Proj. No.: H0562C  
File Loc.: Westminster

California Regional Water Quality Control Board  
Central Coast Region  
895 Aero Vista Drive, Suite 101  
San Luis Obispo, CA 93401

**RE: REVIEW OF OLIN STATEMENT REGARDING NORTHEAST FLOW**

Attachment 2.4: Deep aquifer ternary groundwater gradient direction figures from Mactec 4th Quarter, 2005; 1st Quarter 2006 and 2nd Quarter 2006 Reports (data are included from 3rd Quarter, 2005 in the 4th Quarter, 2005 Report).

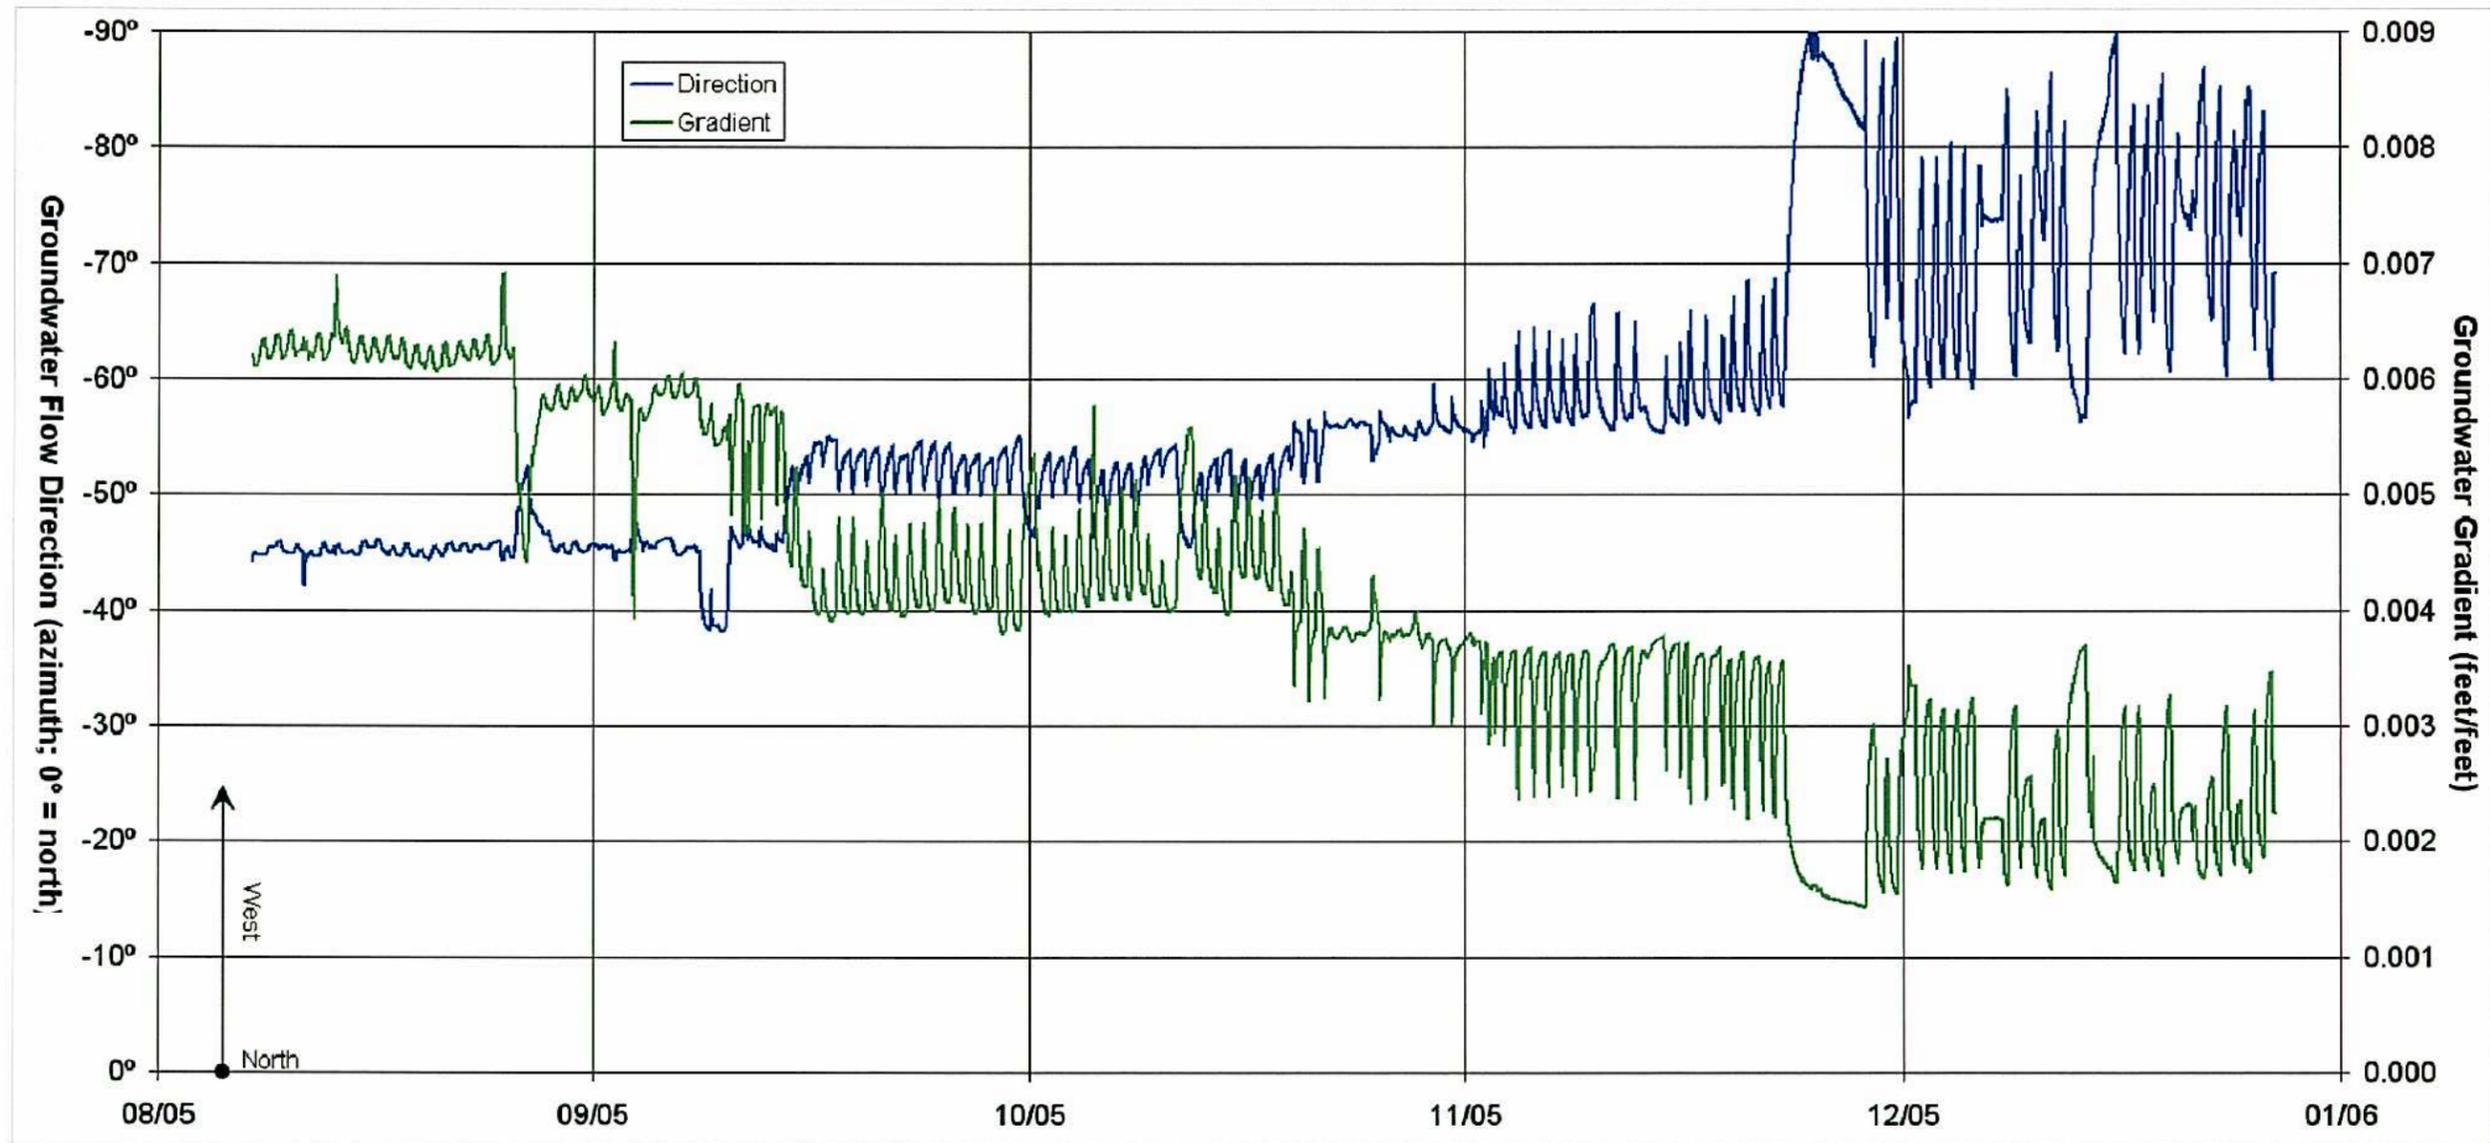
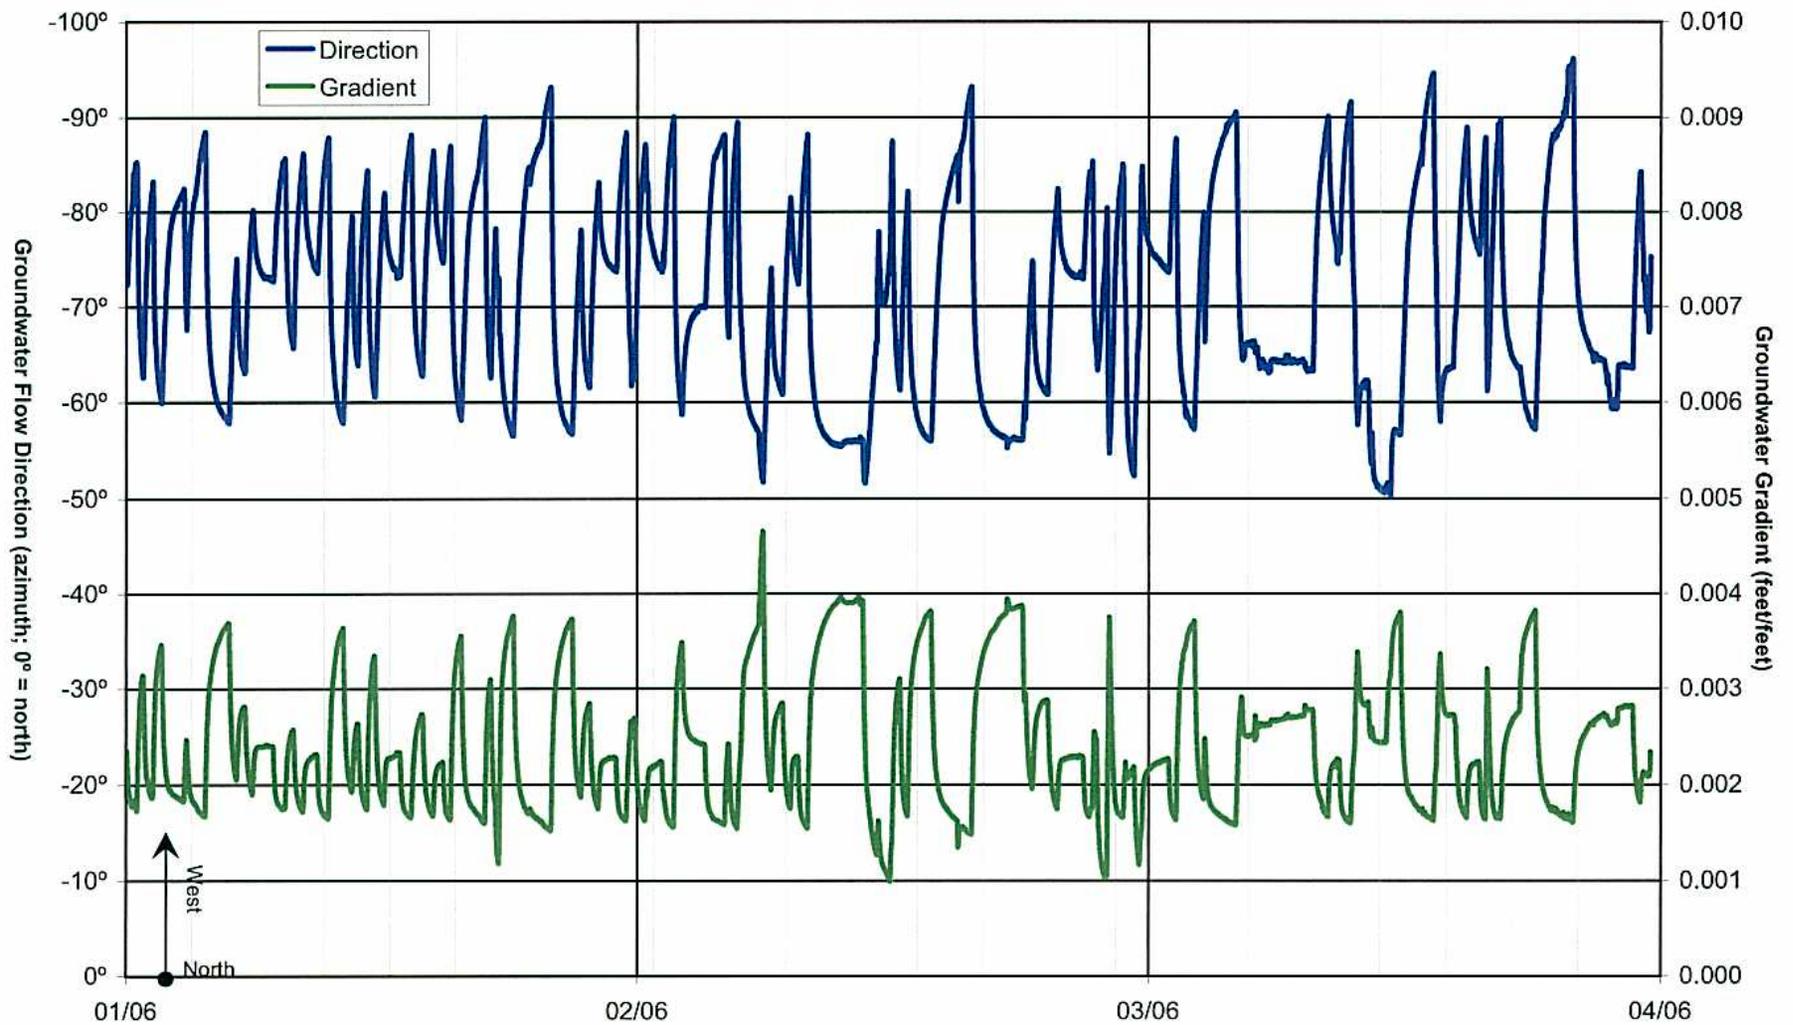
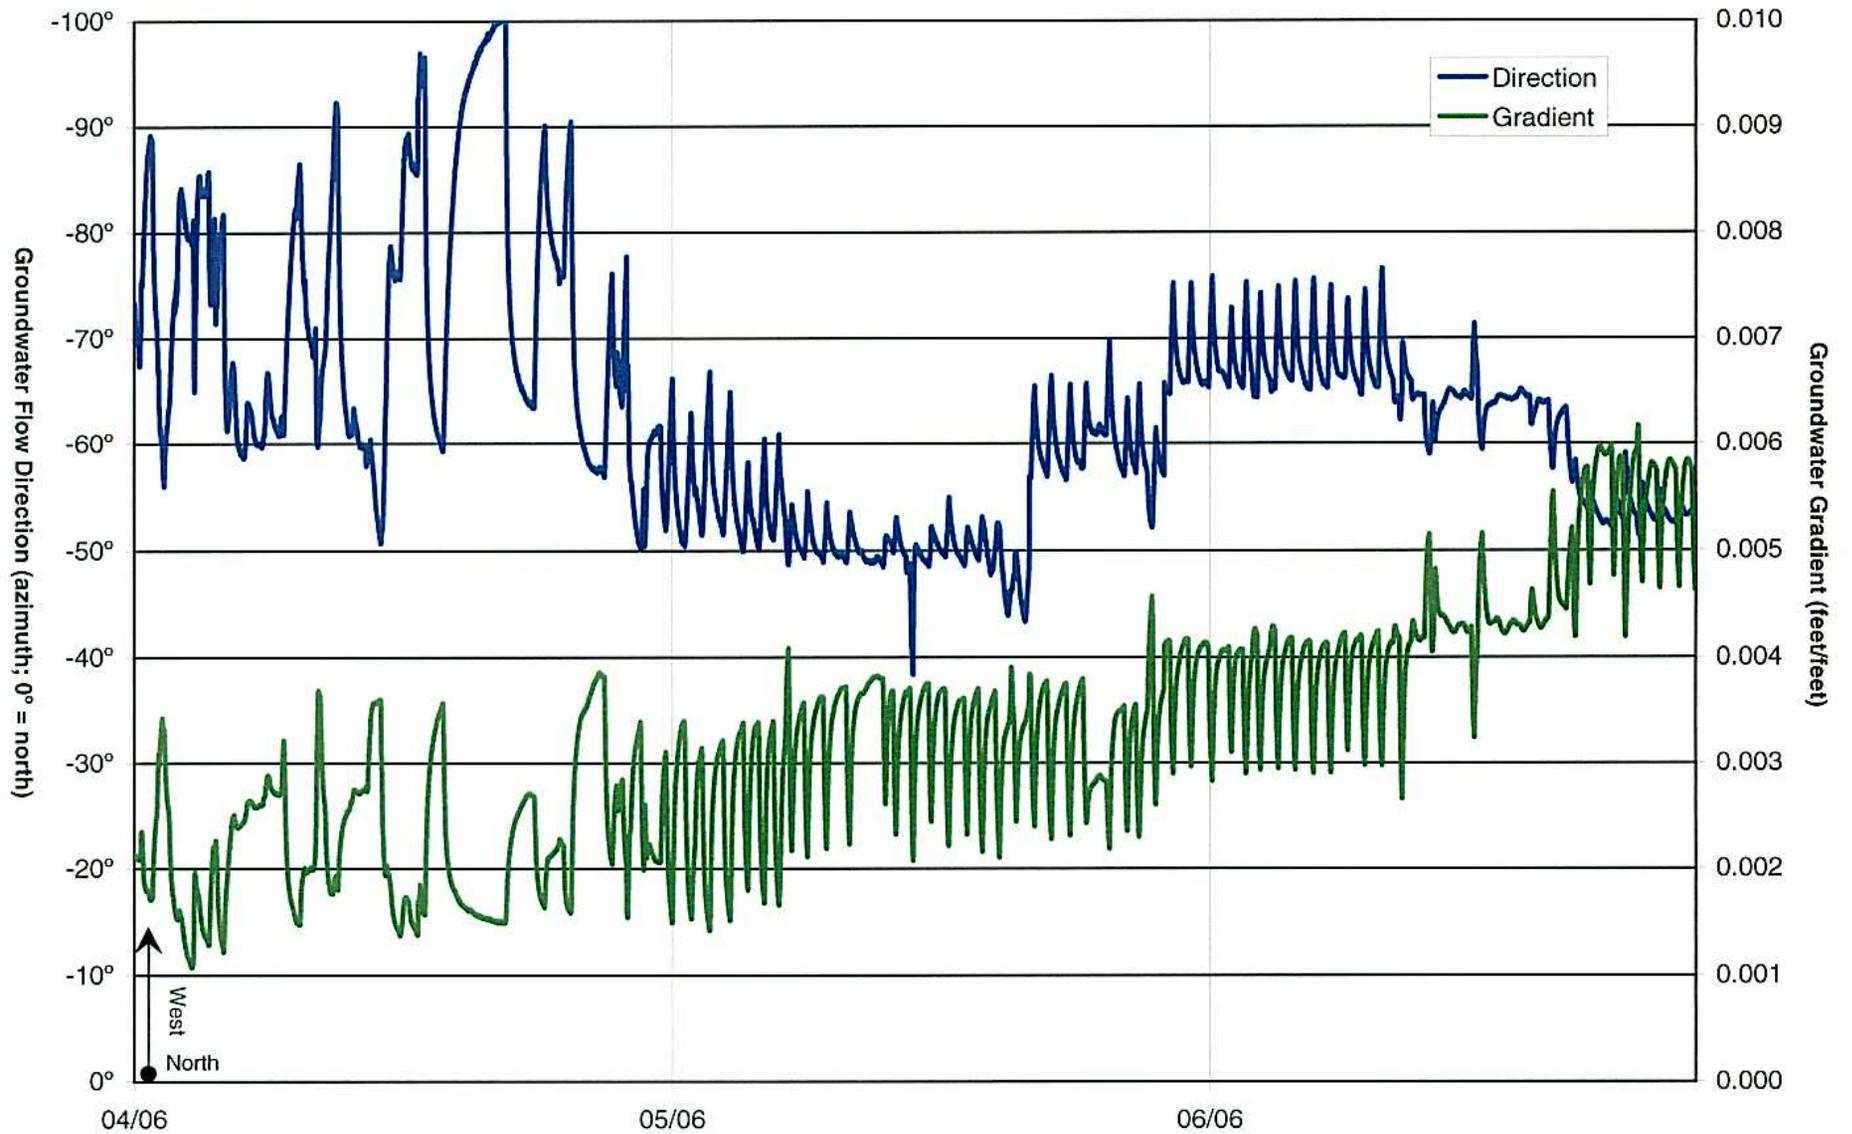
- d. Ternary flow diagrams prepared by Olin's consultant for the gradient between three northeast piezometers, illustrating a consistent predominantly north component of flow for one year (Attachment 2.4).

Attachment 5.1: Figure from Mactec March 29, 2006 Llagas Subbasin Characterization Report  
Illustrating Nitrate Concentrations in the Intermediate Aquifer

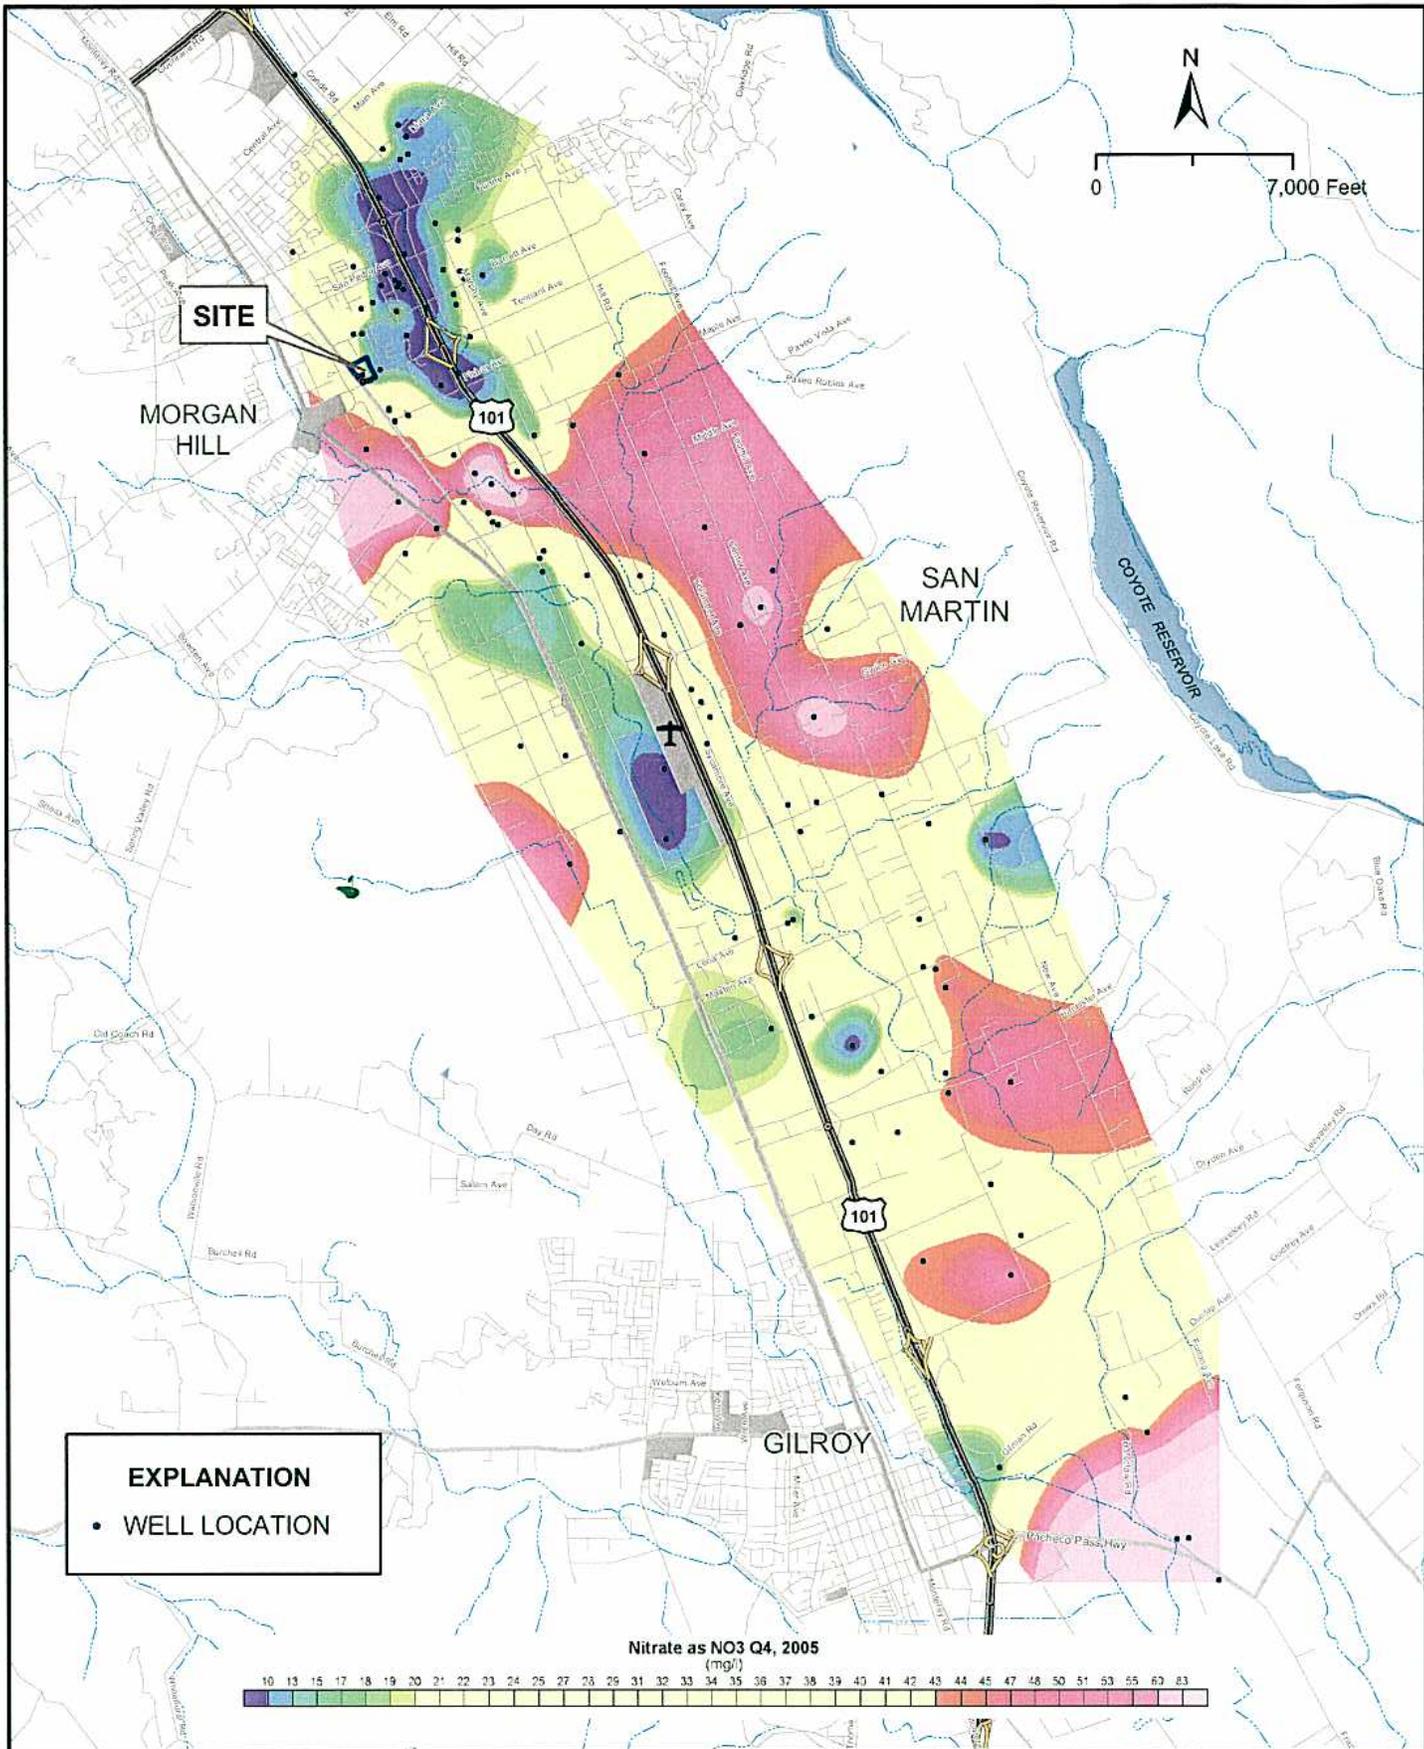
- 5) Olin implies that the nitrate concentrations in groundwater north of the Olin Site are distinguishable from groundwater south of the Olin Site. This assertion does not have any significant bearing on perchlorate migration and is incorrect, based on Olin's interpretation of nitrate distribution in the intermediate aquifer shown in Attachment 5.1. However, suggestions by others have been made that lower concentrations of nitrate to the northeast of the Olin Site are inconsistent with Olin being the source of perchlorate to City wells. This theory is not valid in that:

- a. the contribution of nitrate to groundwater from the Olin Site is low (possibly contributing ug/L concentrations) compared to basin-wide nitrate loading (resulting in milligram per liter concentrations), that would make any nitrate contribution from Olin indistinguishable (as supported by nitrate source data compiled by the Lawrence Livermore National Laboratory [LLNL] in Attachment 5.2);
- b. the nitrate distribution north and south of the Olin Site is highly variable (as depicted by Mactec in Attachment 5.1); and,
- c. there is not a strong nitrate-to-perchlorate concentration correlation south of the Olin Site, which would be expected if the theories about co-occurrence of perchlorate and nitrate were correct.
